ADDENDUM NO. 1

TO: PLANS AND SPECIFICATIONS FOR STATE OF MISSOURI

Construct Solar Array Building 1270 Fort Leonard Wood, Missouri PROJECT NO.: T2229-01

1 SOLAR PANEL ROOF SUPPORT DETAIL

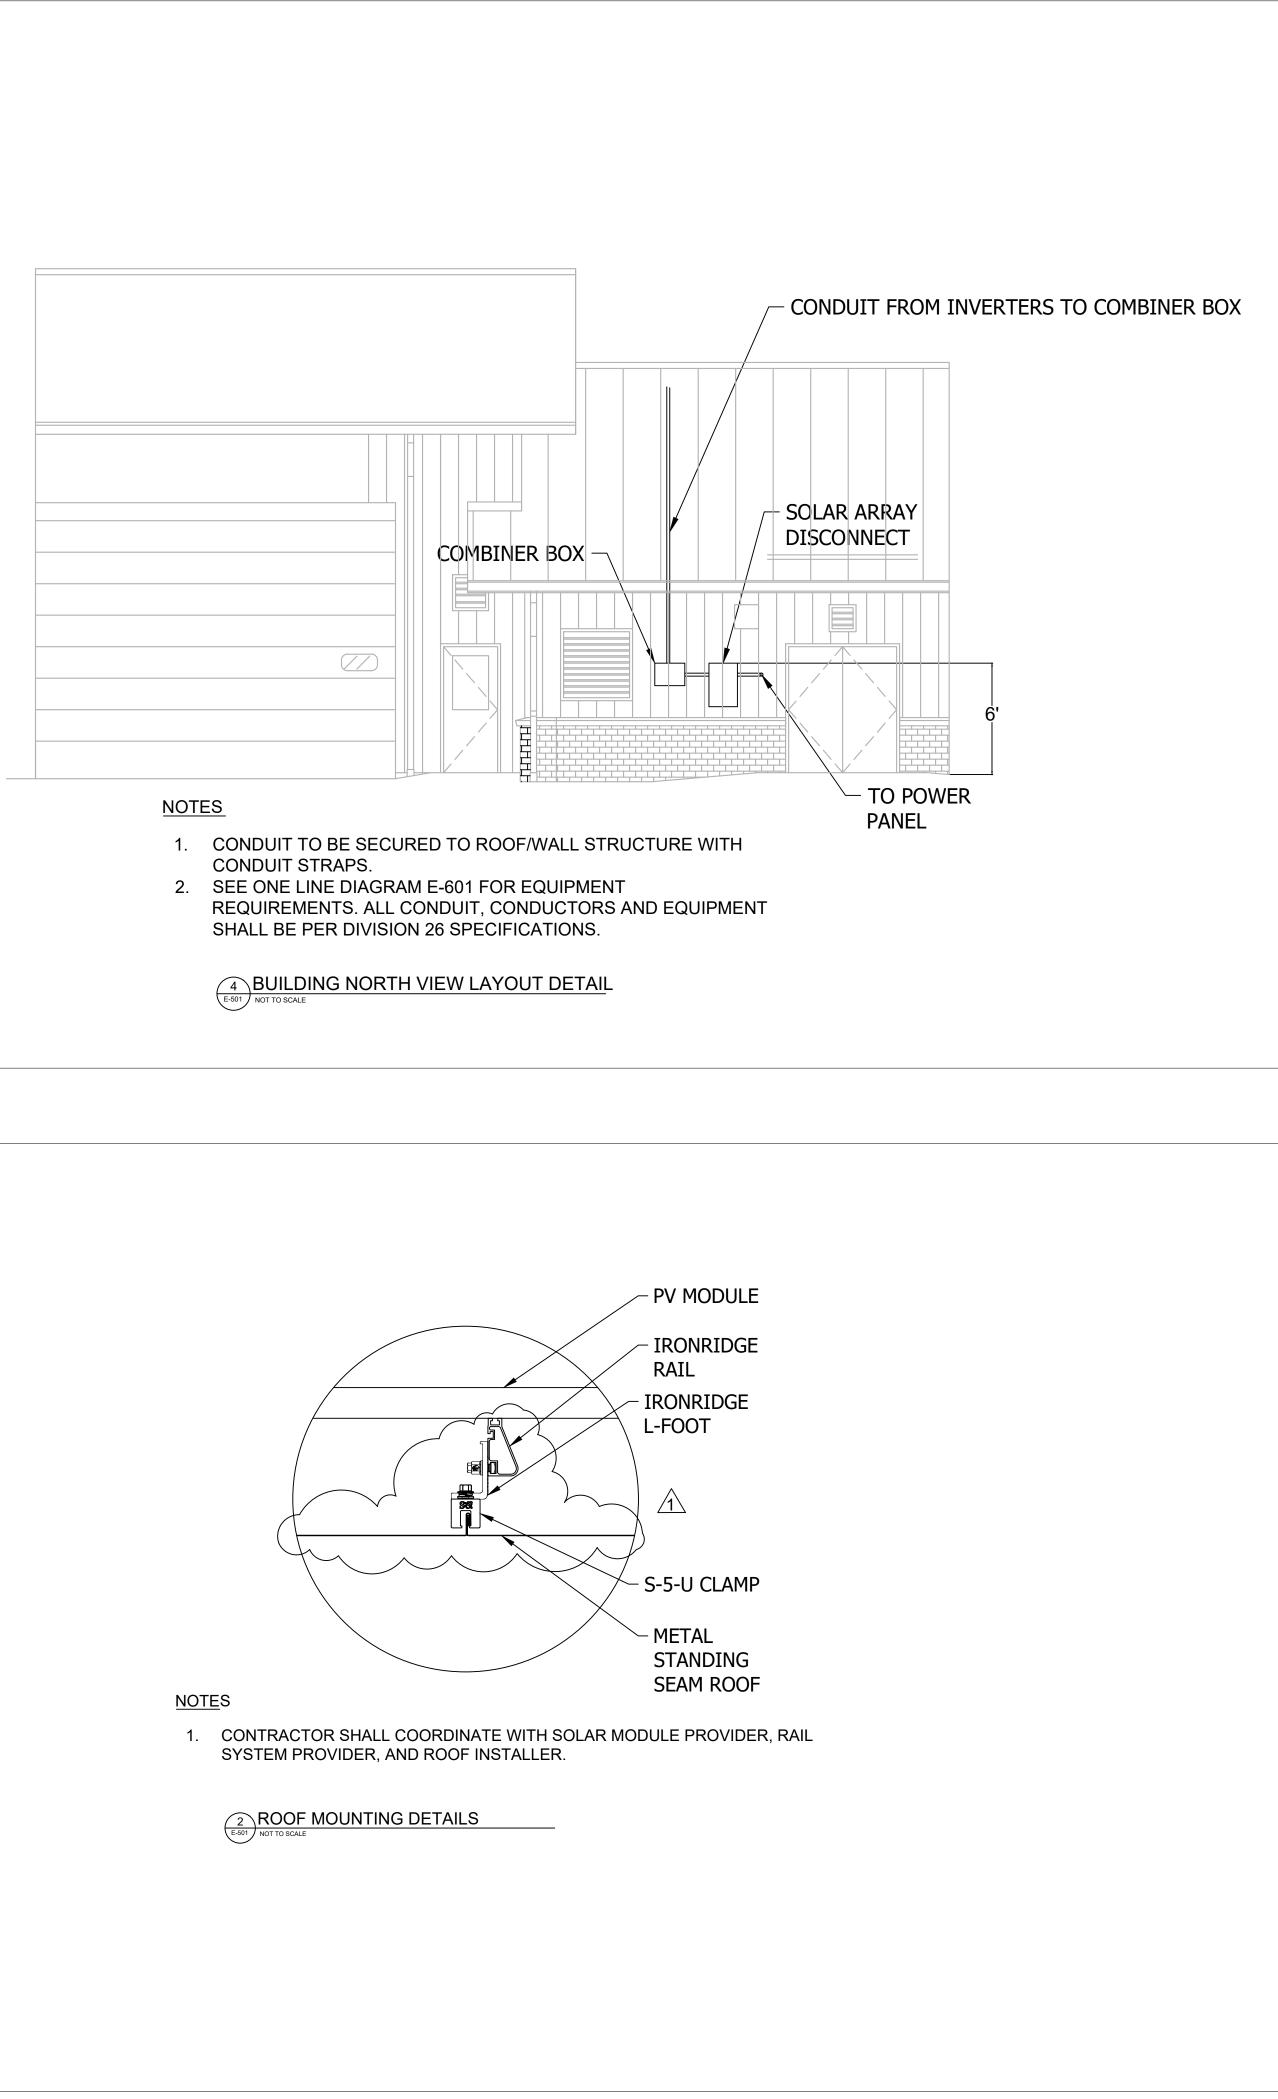
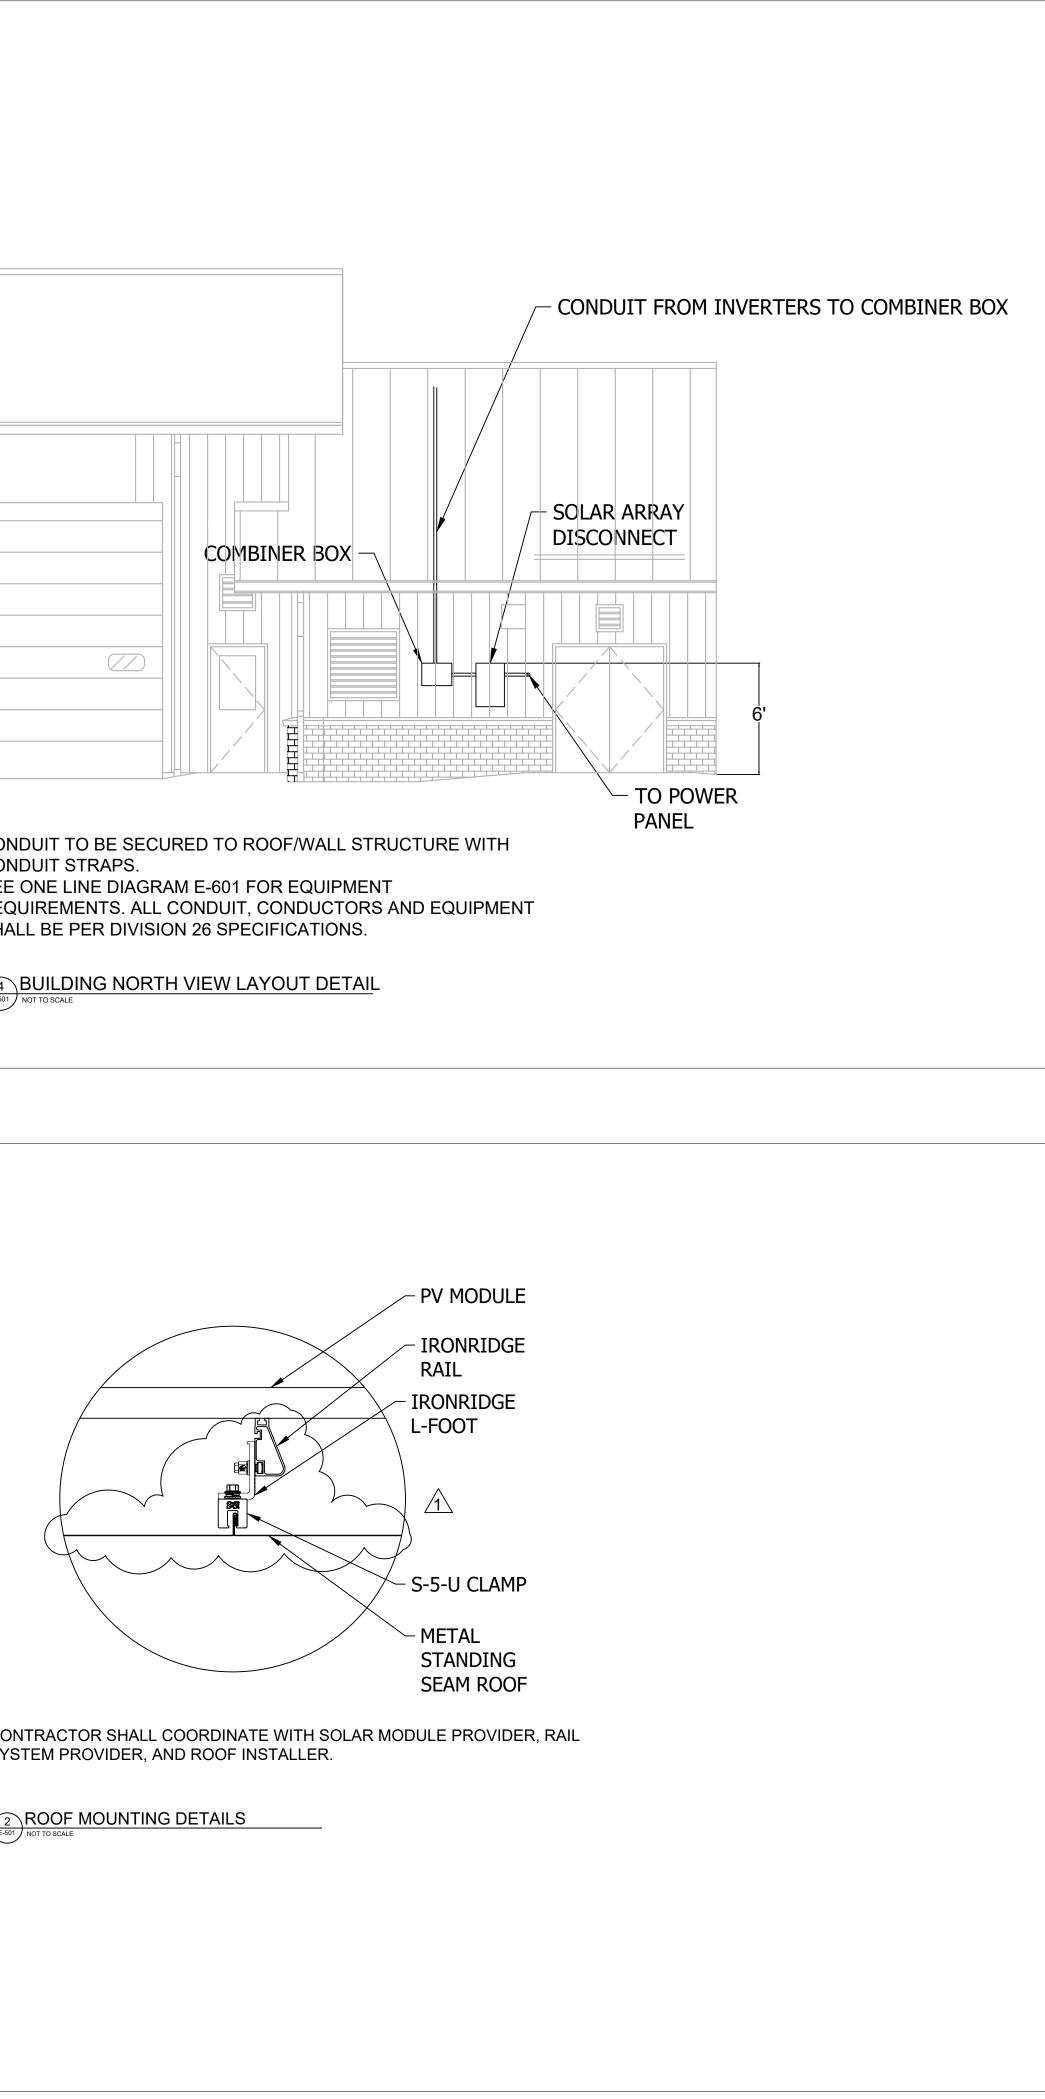
1. <u>Sheet E-501</u>

Details 1 and 2 were revised due to a printing error. See attached revised sheet.
